CHAPTER 3 – REVISIONS, CLARIFICATIONS, AND CORRECTIONS TO THE DRAFT EIR

670 Mesquit

Figure V-1
Railway Properties Ownership - Alternative 2

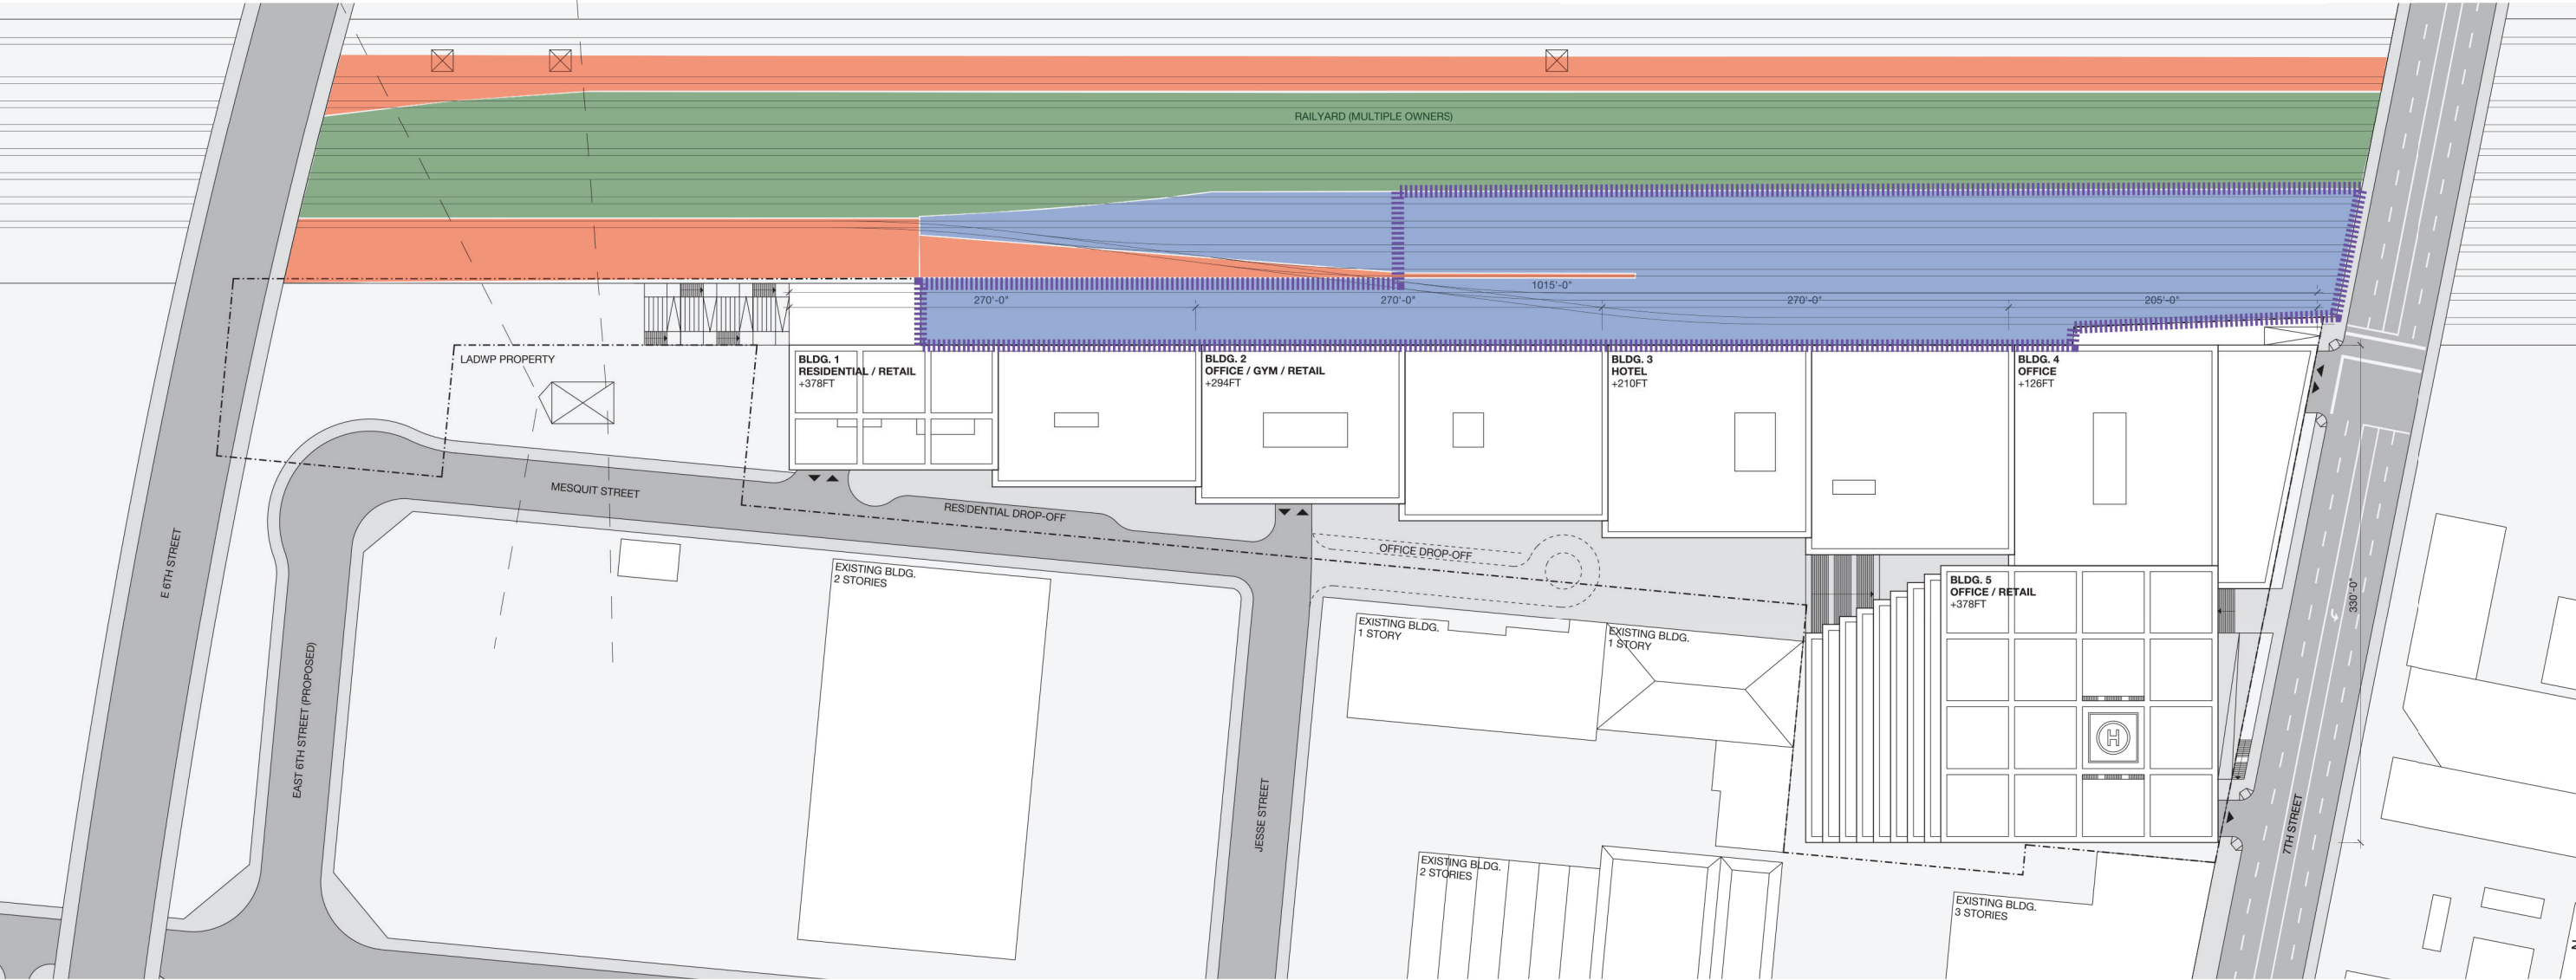
1. Page V-72, Section b), Alternative 2: Reduced Retail and Increased Office with Charter School Alternative, subsection (1), Description of Alternative, revise the last paragraph and add Figure V-1, *Railway Properties Ownership - Alternative 2*, as follows:

Alternative 2 would provide a total of approximately 213,139 square feet of open space for use by Project residents, hotel guests, employees, and visitors. Proposed open space features include at-grade landscaped areas, pedestrian passageways and walkways, balconies offering views of the Los Angeles River, and above-grade landscaped terraces and pool amenity decks. Under Alternative 2, the Northern Landscaped Area, Elevated Pedestrian Walkway, North and South River Balconies, Mesquit Paseo, and Office Terraces would all remain as proposed under the Project. The residential pool deck would be moved from the northern portion of Building 2 to the southern portion of Building 1. The fitness deck would be moved from Building 3 to Building 2. The Work Breakout Deck would remain on the southern portion of Building 2. The rooftop of Building 3 would be comprised of a Hotel Garden and a hotel bar and pool deck. The rooftops of Building 4 and 5 would remain the same as under the Project. Alternative 2 would include a 75,000 square foot Deck as part of its development program, which is reduced as compared to the 132,000 square foot Deck under the Project with the Deck Concept. The Deck under Alternative 2 would extend over a portion of the Railway Properties east of the Project Site. Figure V-1, Railway Properties Ownership – Alternative 2, shows Amtrak, Metro, and BNSF ownership within the Railway Properties under Alternative 2. The same types of programming and events would occur on the Project Site as under the Project. For events that would be located on the Deck, Alternative 2 would have the same type and frequency of events, but would have a reduced capacity of 5,000 people compared to the capacity of 8,800 people under the Project with the Deck Concept due to the smaller Deck under Alternative 2.

Figure V-2
Proposed Street Vacation – Alternative 2

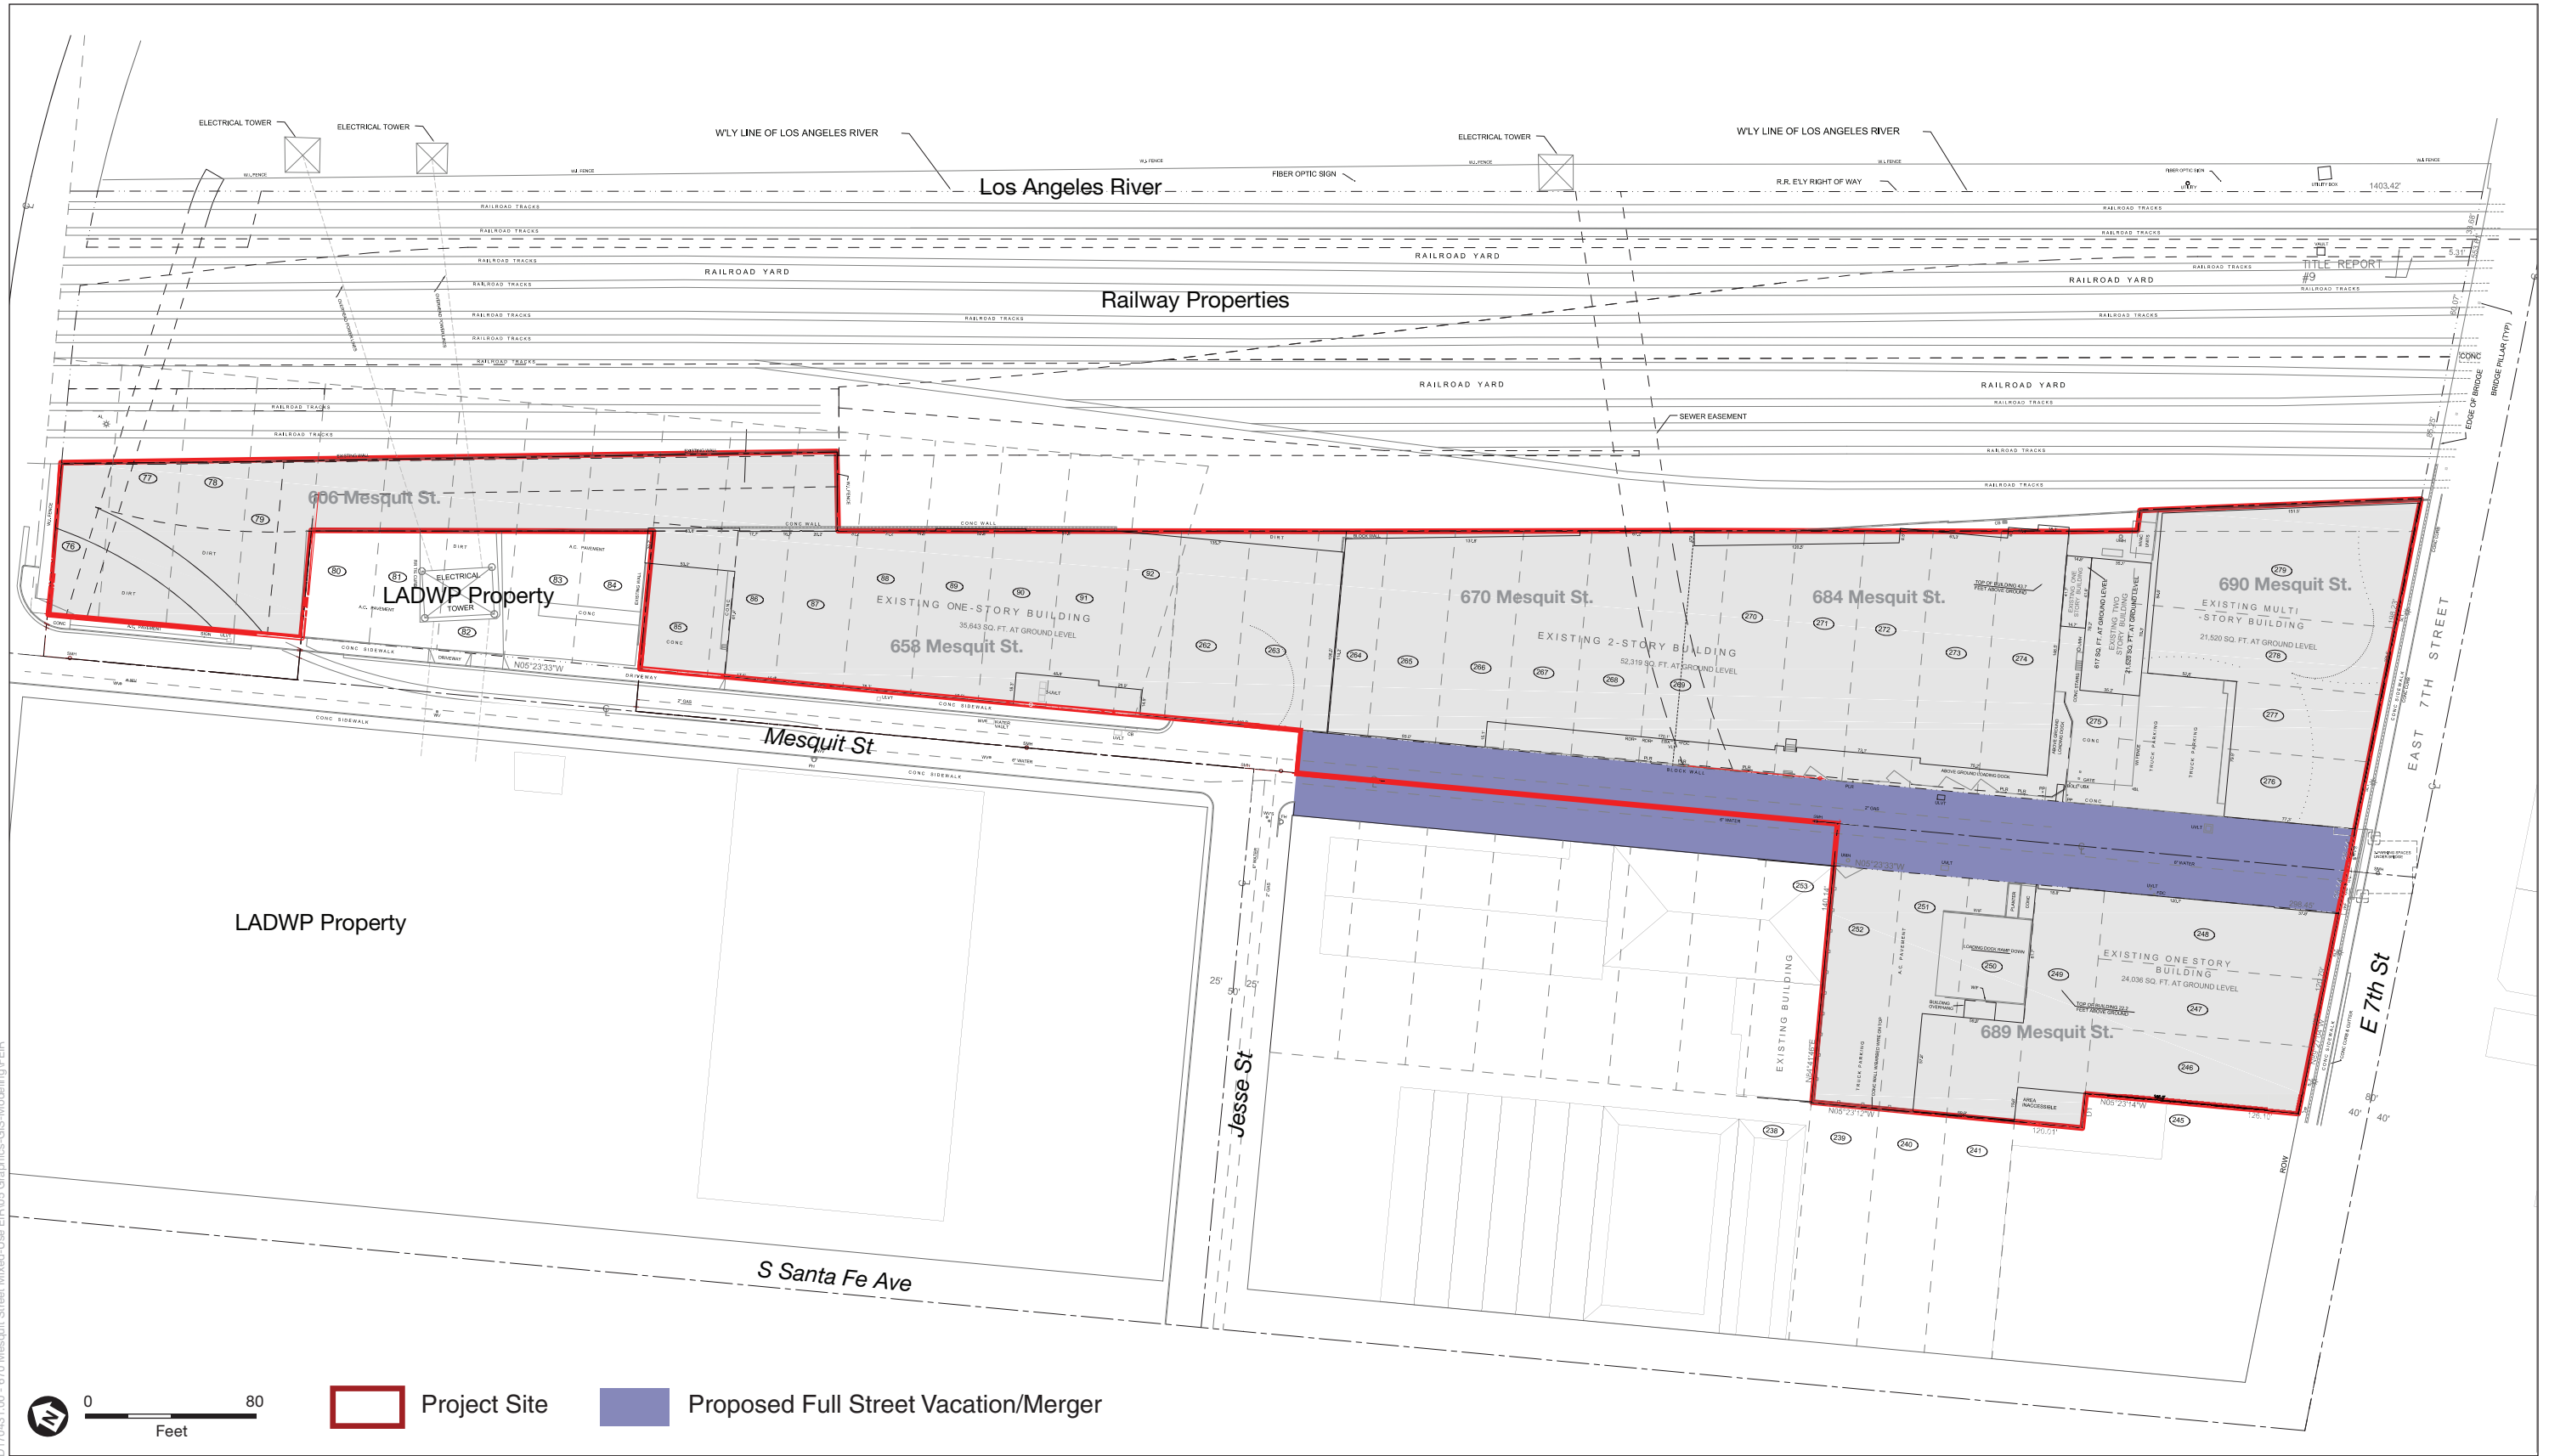
As shown on **Figure V-2, Proposed Street Vacation – Alternative 2**, Alternative 2 proposes a full-width vacation/merger of Mesquit Street from the northerly right-of-way of 7th Street to the southerly right-of-way of Jesse Street. Unlike the Project, Alternative 2 does not propose a half-width subsurface merger for the easterly half of Mesquit Street from the southerly right-of-way of Jesse Street to the southerly line of the LADWP property on the east side of Mesquit Street.

Figure V-3
Railway Properties Ownership - Alternative 3

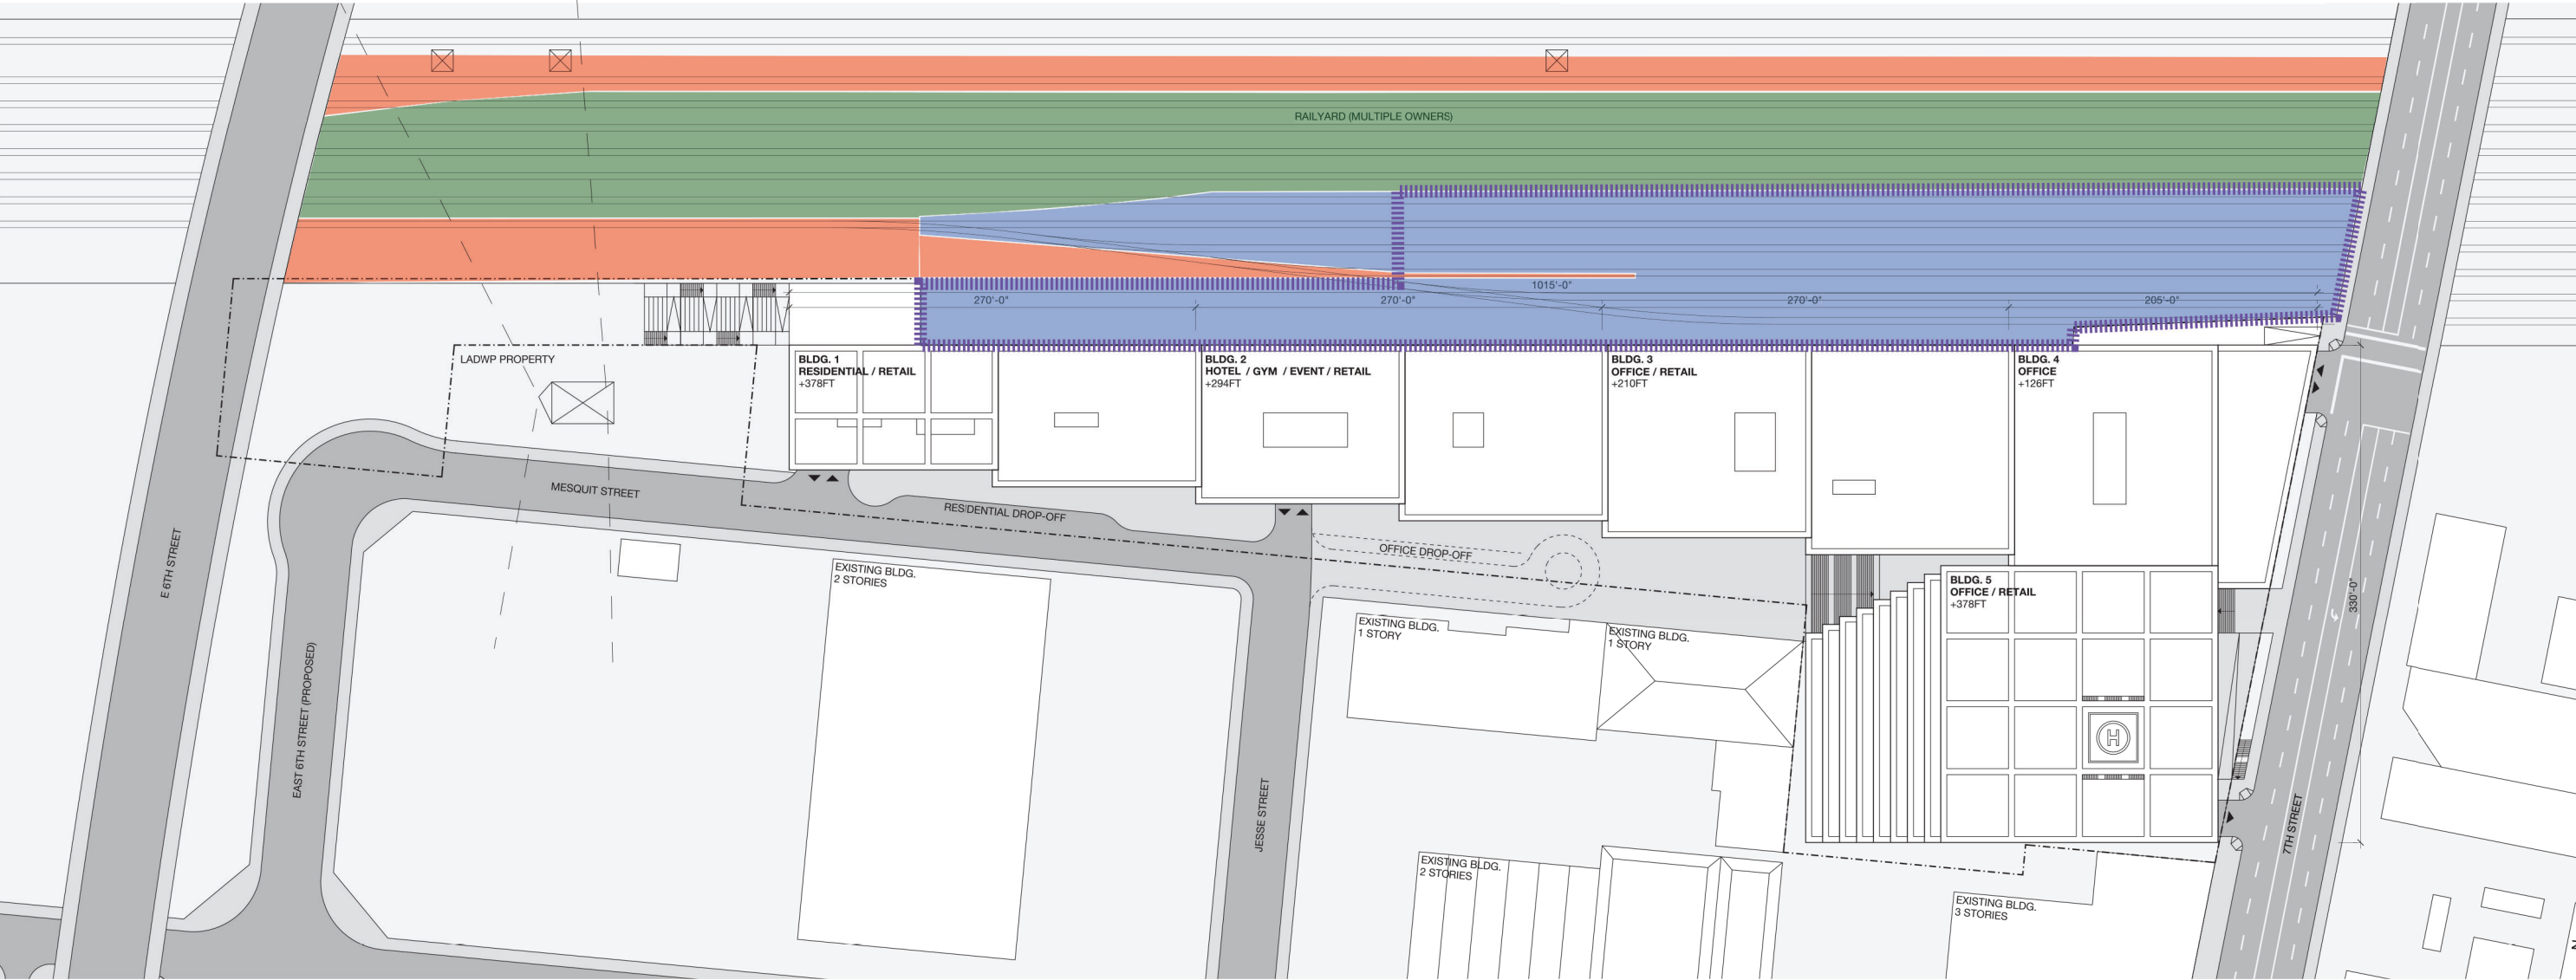
2. Page V-157, Section c) Alternative 3: Reduced Retail and Increased Office and Gym Use Alternative, subsection (1), Description of Alternative, revise the first paragraph and add Figure V-2, *Railway Properties Ownership - Alternative 3*, as follows:

Alternative 3 would provide a total of approximately 214,414 square feet of open space for use by Project residents, hotel guests, employees, and visitors. Proposed open space features include at-grade landscaped areas, pedestrian passageways and walkways, balconies offering views of the Los Angeles River, and above-grade landscaped terraces and pool amenity decks. Under Alternative 3, the Northern Landscaped Area, Elevated Pedestrian Walkway, North and South River Balconies, Mesquit Paseo, and Office Terraces would all remain as proposed under the Project. The residential pool deck would be moved from the northern portion of Building 2 to the southern portion of Building 1. The Hotel Garden and hotel bar and pool deck would be moved from the southern portion of Building 1 to the entire rooftop of Building 2. The fitness deck would be moved from the southern portion of Building 3 to the northern portion of Building 3. The Work Breakout Deck would move from the southern portion of Building 2 to the southern portion of Building 3. The sculpture garden would be removed under Alternative 3. The rooftop of Building 4 would be comprised of an office plaza flex deck, which would only be usable by the office employees. Alternative 3 would include a 75,000 square foot Deck that would extend over a portion of the Railway Properties east of the Project Site. **Figure V-3, Railway Properties Ownership – Alternative 3, shows Amtrak, Metro, and BNSF ownership within the Railway Properties under Alternative 3.** The same types of programming and events would occur on the Project Site as under the Project. For events located on the Deck, Alternative 3 would have the same type and frequency of events, but would have a reduced capacity of 5,000 people compared to the capacity of 8,800 people under the Project with the Deck Concept due to the smaller Deck under Alternative 3.
